Wilder Park

Wilder Park is very large park that is centrally located in the downtown area and provides elements and programs including parking, gardens, Conservatory, a mansion, the main administration building, playground, preschool program, picnic tables and grills. The main issues at this park are slopes too steep, reach ranges too high, proper picnic table designs, protruding branches, accessible routes, and door forces. **Please Note:** When a **UD** is indicated, this is a Universal Design (**UD**) recommendation to enhance accessibility. The **UD** recommendation is not required to meet the minimum accessibility standards but it would be encouraged.

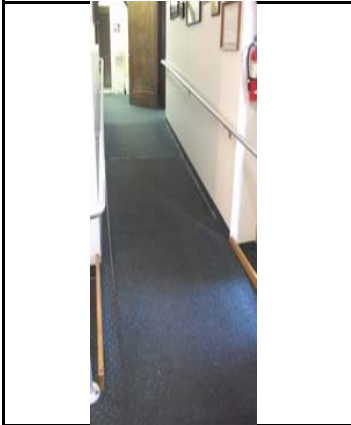
Photo	Barrier	ADAAG/IAC	Solution	Priority	By Whom	Projected Cost	Projected Date	Action Taken
	The Elizabeth Friendship walkway has vines at the east arch entrance that protrudes at 59" AFF to 79" AFF.	ADAAG 307	Trim the branch to provide an 80" minimum clear head space and back to the edge of the walkway.			\$50	2012	Staff trimmed branches 2/2012
	The Elizabeth Friendship walkway has vines at the south arch entrance that protrudes at 50" AFF to 79" AFF.	ADAAG 307	Trim the branch to provide an 80" minimum clear head space and back to the edge of the walkway.			\$50	2012	Staff trimmed branches 2/2012
	A tree east of the south arch has branches that protrude 41" AFF to 79" AFF.	ADAAG 307	Trim the branch to provide an 80" minimum clear head space and back to the edge of the walkway.			\$50	2012	Staff trimmed branches 2/2012
	The south arch of the herb garden has vines that protrudes at 50" AFF to 79" AFF.	ADAAG 307	Trim the branch to provide an 80" minimum clear head space and back to the edge of the walkway.			\$50	2012	Staff trimmed branches 2/2012

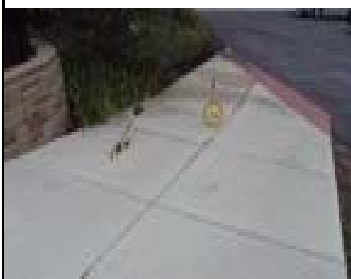
Photo	Barrier	ADAAG/IAC	Solution	Priority	By Whom	Projected Cost	Projected Date	Action Taken
	Rock work arch in the east side of the building protrudes at 39" AFF to 79" AFF.	ADAAG 307	Lower the element below 27" or provide a cane detectable barrier below 27" and the width of the protruding object.			\$500	TBD	
	The walkway east of the memorial area has a cross slope too steep at 2.6% to 3.4% for 15'.	ADAAG 403.3	Attempt a "mud jacking" technique or remove and regrade section to provide a cross slope no greater than 2%.			\$900	2014	Redeveloped walks to meet standards in 2014
	The walkway through the parking lot from the Administration Building to the back of the mansion has a cross slope too steep at 2.6% to 8.9% for 121'	ADAAG 403.3	Regrade section to provide a cross slope no greater than 2%.			\$4,000	2024

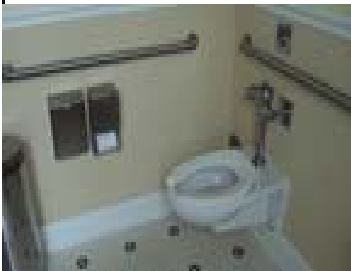
Photo	Barrier	ADAAG/IAC	Solution	Priority	By Whom	Projected Cost	Projected Date	Action Taken
	<p>The tampon disposal in the women's southwest restroom is mounted too far from the toilet at 17".</p>	<p>ADAAG 308</p>	<p>Relocate the tampon trash can to be no more than 9" maximum in front of the toilet if mounted on the sidewall or no more than 20" from the toilet if mounted on the back wall. The tampon trash can should be mounted no higher than 48" on either wall.</p>			<p>\$100</p>	<p>2018</p>	<p>Remounted tampon disposal 6/2018</p>
	<p>The baby changing table in the southwest women's restroom is mounted too high at 37 1/2" AFF to the surface and 58" AFF to handle and is not accessible being located in an alcove.</p>	<p>IAC 400.320(w)</p>	<p>Replace or remount the baby changing table to be no higher than 34" AFF and provide a minimum knee clearance of 27". Also mount it so the handle is no higher than 48" AFF. Mount the baby changing table to a location that provide a clear floor space that complies with ADAAG 305.</p>			<p>\$250</p>	<p>2018</p>	<p>remounted baby changing station 6/2018</p>

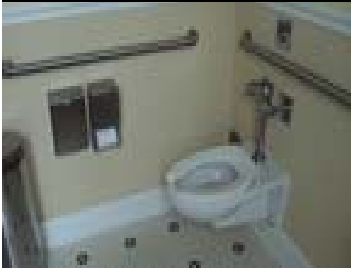
Photo	Barrier	ADAAG/IAC	Solution	Priority	By Whom	Projected Cost	Projected Date	Action Taken
	<p>The baby changing table in the south west men's restroom is mounted too high at 37" AFF to surface and 58" AFF to handle and is not accessible being located in an alcove.</p>	<p>IAC 400.320(w)</p>	<p>Replace or remount the baby changing table to be no higher than 34" AFF and provide a minimum knee clearance of 27". Also mount it so the handle is no higher than 48" AFF. Mount the baby changing table to a location that provide a clear floor space that complies with ADAAG 305.</p>			\$250	2018	<p>remounted baby changing station 6/2018</p>
	<p>The door to the Area of Rescue Assistance on the second floor has a door opening force too high at 14 lbs.</p>	<p>ADAAG 404.2.8 & ADAAG 404.2.9</p>	<p>Adjust the closer so the door opening force is no heavier than 5 lbs. to open and takes a minimum of 5 seconds to close or provide an automatic door opener at one of the doors.</p>			\$100	2012	<p>Adjusted opening force to 5 lbs.</p>

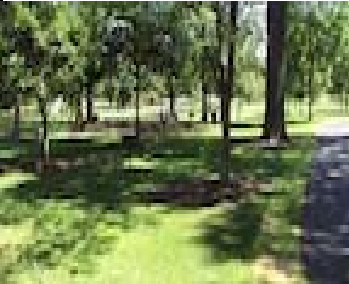
The east walkway along the preschool building toward the back has a cross slope too steep at 2.6% to 6.0% for 36'.	ADAAG 403.3	Attempt a "mud jacking" technique or remove and regrade section to provide a cross slope no greater than 2%.			\$2,160	2024

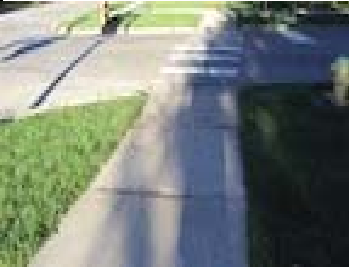
Photo	Barrier	ADAAG/IAC	Solution	Priority	By Whom	Projected Cost	Projected Date	Action Taken
	The coal pit at Picnic area #6 is not on an accessible route for 84'.	ADAAG 403.3	Relocate to an accessible route or provide a new accessible route with a running slope no steeper than 5% and a cross slope no steeper than 2% and a minimum clear width of 36"			\$2,775	2024	
	The walkway at the bike rack near the playground has a branch that protrudes at 53" AFF.	ADAAG 307	Trim the branch to provide an 80" minimum clear head space and back to the edge of the walkway.			\$50	2012	Branches trimmed 5/2012
	The accessible parking space at the playground has a running slope too steep at 2.6% to 4.3%.	ADAAG 502.4	Regrade the parking spaces on the shortest accessible route to be no steeper than 2% in all directions.			\$900	2024	
	There are two picnic tables provided at the playground but only one is of an accessible design.	<u>Proposed</u> Outdoor Developed Areas Guidelines ADAAG 245 & 1011	Picnic Table Recommendation: At least 20% of picnic tables, but no less than two, be of accessible design, connected to an accessible route. Relocate or purchase one more accessible picnic table and locate it on an accessible surface.			\$750	2019

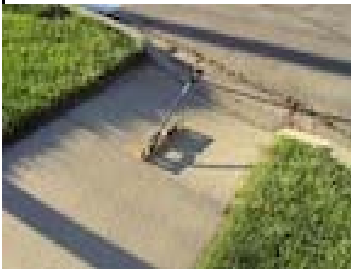
Photo	Barrier	ADAAG/IAC	Solution	Priority	By Whom	Projected Cost	Projected Date	Action Taken
	The checker table is of an accessible design but it only provides a 25 1/2" knee clearance.	ADAAG 226 & ADAAG 902	Raise the table to provide a minimum 27" knee clearance and a table height between 28" and 34" as needed.			\$750	2019	
	The surface up to the tire swing has a running slope 5.6% to 8.9% for 3'.	ADAAG 1008.2.5.1	The ground level ramp running slopes can be no steeper than 6.25% with a cross slope not steeper than 2%. At the time of the survey, it was understood that the installer was returning to correct this slope.			NA	2012	Corrected by contractor as part of warranty

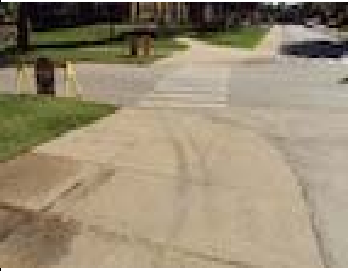
The south curb ramp at the south east corner has a cross slope too steep at 9.7%.	ADAAG 406	Provide a curb ramp with a running slope no steeper than 8.3% and a cross slope no steeper than 2% and a smooth transition to the sidewalk and street gutter.			\$1,500		Coordinate with City's sidewalk replacement program

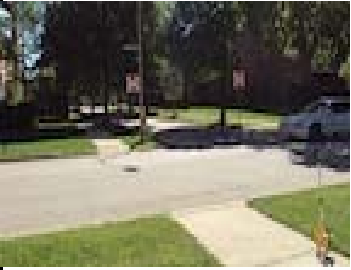
Photo	Barrier	ADAAG/IAC	Solution	Priority	By Whom	Projected Cost	Projected Date	Action Taken
	The east sidewalk behind Lizzard Museum has a cross slope too steep at 2.6% to 3.4% for 16'.	ADAAG 403.3	Attempt a "mud jacking" technique or remove and regrade section to provide a cross slope no greater than 2%.			\$960	2019	
	The curb ramp creates a cross slope too steep at 8.0% for 16'.	ADAAG 406	Provide an inline or parallel curb ramp with a running slope no steeper than 8.3% and a cross slope no steeper than 2% and a smooth transition to the sidewalk and street gutter.			\$1,500	2019	
	The east sidewalk north of the museum even with the picnic area has a branch that protrudes at 68" AFF.	ADAAG 307	Trim the branch to provide an 80" minimum clear head space and back to the edge of the walkway.			\$50	2012	Trimmed branch 3/2012
	The east sidewalk at the picnic area south of the drive to playground construction has a branch that protrudes at 67" AFF.	ADAAG 307	Trim the branch to provide an 80" minimum clear head space and back to the edge of the walkway.			\$50	2012	Trimmed branch 3/2012

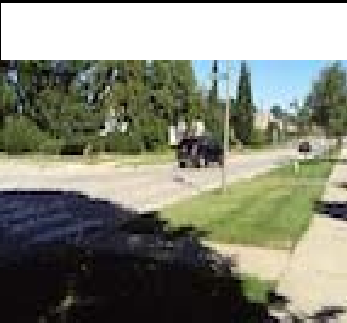
The sidewalk directly east of the new playground has a cross slope too steep at 2.6% to 3.4% for 37'.	ADAAG 403.3	Attempt a "mud jacking" technique or remove and regrade section to provide a cross slope no greater than 2%.			\$900	Coordinate with City's sidewalk replacement program
